State of New Mexico
Energy, Minerals and Natural Resources

Form C-103
Revised July 18, 2013

CALMON 30 STATE 001

NOI TO PERMANENTLY ABANDON THIS WELL VIA CEMENT PLUGGING.

Proposed Wellbore
CALMON 30 STATE 001

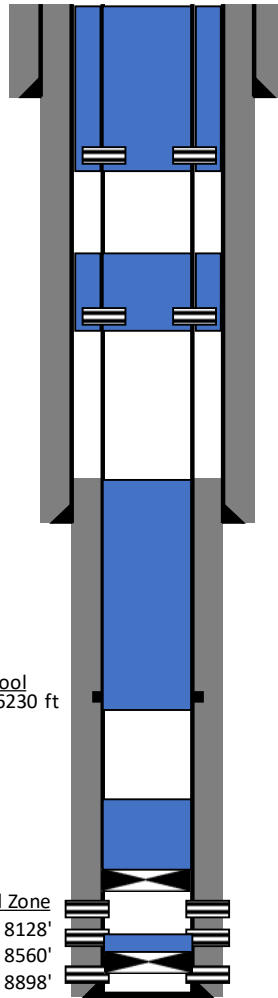
1. POOH WITH EXISITNG 2-3/8" TBG AND BHA
2. RIH AND TAG EXSITING CIBP AT 8812'
3. SPOT 19 SX CL H CMT FROM 8812' TO 8560'. WOC AND TAG
4. SET CIBP AT 8066' VIA WORKSTRING. LEAK TEST **Surface to TD** TO 500 PSI FOR 30 MINUTES - **BubbleTest**
5. SPOT 78 SX CL H CMT FROM 8066' TO 7013'. POOH
6. RUN CBL FROM 6900' **with zero psi, keep hole loaded and log** TO SURFACE PER OCD REQUIRMENTS. REVIEW WITH OCD
7. RIH AND TAG CMT AT 7013'
8. SPOT 131 SX CL C CMT FROM 6280' TO 4300'. WOC AND TAG
9. PERF AND SQUEEZE 55 SX CL C CMT FROM 3300' TO 3000'. WOC AND TAG - **WOC & Bubble Test**
10. PERF AND CIRCULATE 316 SX CL C CMT FROM 1729' TO SURFACE - **WOC & bubble Test**
11. VERIFY CMT TO SURFACE
